DESCRIPTION: LTR NOTORIZED 5-7-76.....
LTR REQUESTING APPROVAL OF TECH SPEC CHANGE
FOR REORGANIZATION TO PROVIDE A MORE
EFFICIENT OVERALL MAINT ORGANIZATION.....

Re: Oconee Nuclear Station
Docket Nos. 50-269, 50-270, 50-287

OCONEE NUCLEAR STATION
STATION ORGANIZATION CHART
FIGURE 6.1-1

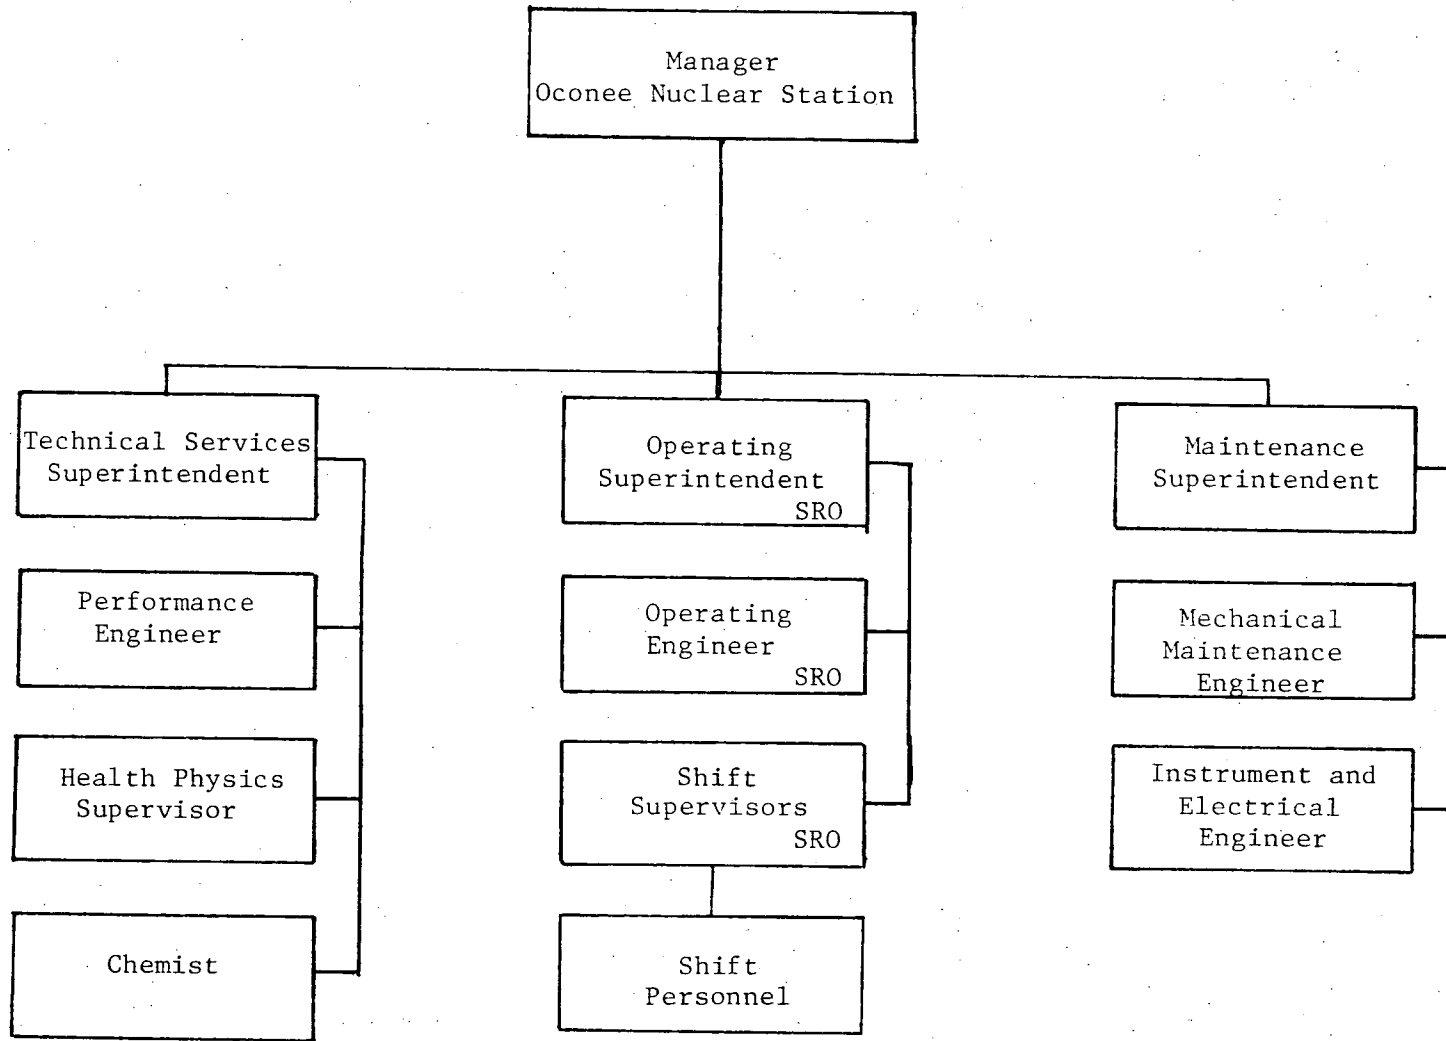
Pursuant to 10 CFR 50, Section 50.90, an amendment to Section 6.1 of the Oconee Nuclear Station Technical Specifications, Appendix A to Facility Operating Licenses DPR-38, -47, and -55 is proposed. Specifically, please find attached a proposed change to Figure 6.1-1 entitled "Station Organization Chart". This chart is referenced by Technical Specification 6.1.1.3 and depicts the station organization for Operations, Technical Services, and Maintenance. Proposed changes to the station organization as reflected by this chart are as follows:

The "Instrument and Control" section has been redesignated as the "Instrument and Electrical" section, and the "Maintenance" section has been redesignated as the "Mechanical Maintenance" section.

By redistributing personnel assignments, the Maintenance Organization is more effectively divided into two more distinct branches, with one branch responsible for only mechanical maintenance and the other only for electrically-related maintenance. This reorganization provides a more logical assignment of maintenance personnel and thereby will afford a more efficient overall Maintenance Organization.
